PLANNING REPORT

Planning and Zoning Commission

Dublin Scioto High School 25-010AFDP

Address	4000 Hard Road Dublin, OH 43016
Proposal	Proposal for an Amended Final Development Plan for additions to the school building. The 65.25-acre site is zoned PUD: NE Quad and is located north of the Hard Road and Bryson Cove Circle intersection.
Request	Request for review and approval of an Amended Final Development Plan under the provisions of Zoning Code Section 153.055.
Zoning	PUD: NE Quad
Planning Recommendation	<u>Approval of an Amended Final Development Plan</u> with conditions
Next Steps	Upon approval of the AFDP, the applicant may apply for permits through Building Standards.
Applicant	Michael Myers, Fanning Howey
Case Manager	Tammy Noble, Senior Planner (614) 410-4649 tnoble@dublin.oh.us

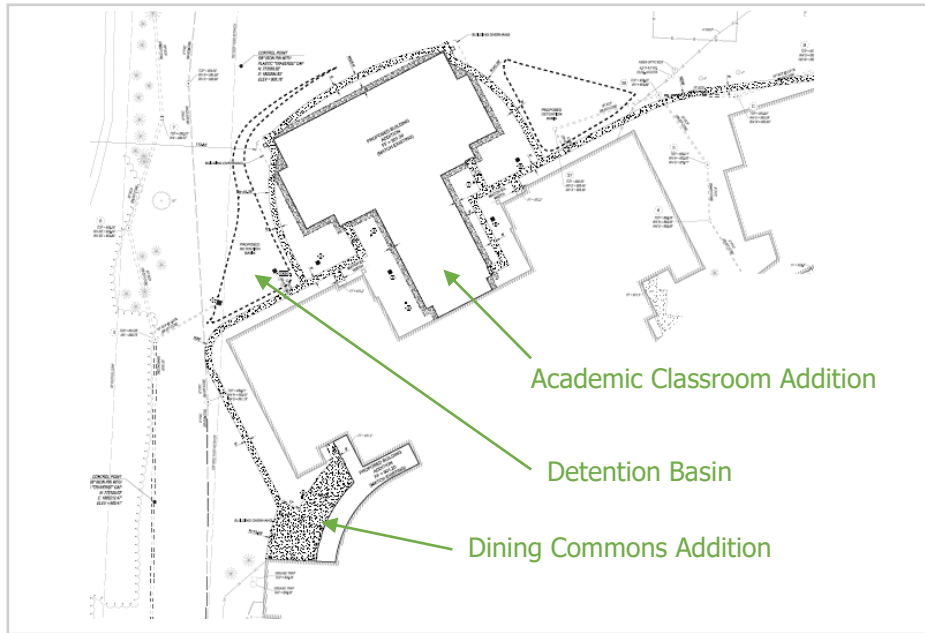
The existing primary building is located in the southwest portion of the site and includes six sections of building that are interconnected for a total square footage of 297,720 square feet. The site has two parking areas; one for staff and the other for students. There are three access points extending from Hard Road. One is located on the east side of the property which provides access into the student and staff parking areas, and the second and third access points are located in the center and western portion of the property to create a circular drop off area for students and bus traffic.

The proposed development includes two additions. The first addition is a two-story, 56,000 square-foot academic wing to be located between two existing wings at the rear of the building. It would provide educational classrooms, science labs, and supporting space. The second addition is proposed on the west side of the building and includes a 6,250 square-foot expansion of the existing student dining area. The expansion would include both internal and outdoor dining areas. The outdoor dining area would also include a roof overhang supported by brick columns that would allow students to use the space during inclement weather. The two additions will be connected by a pedestrian pathway to allow pedestrian movement from

both areas of the building. The proposal also include a new detention basin that will be located to the west of the academic addition.
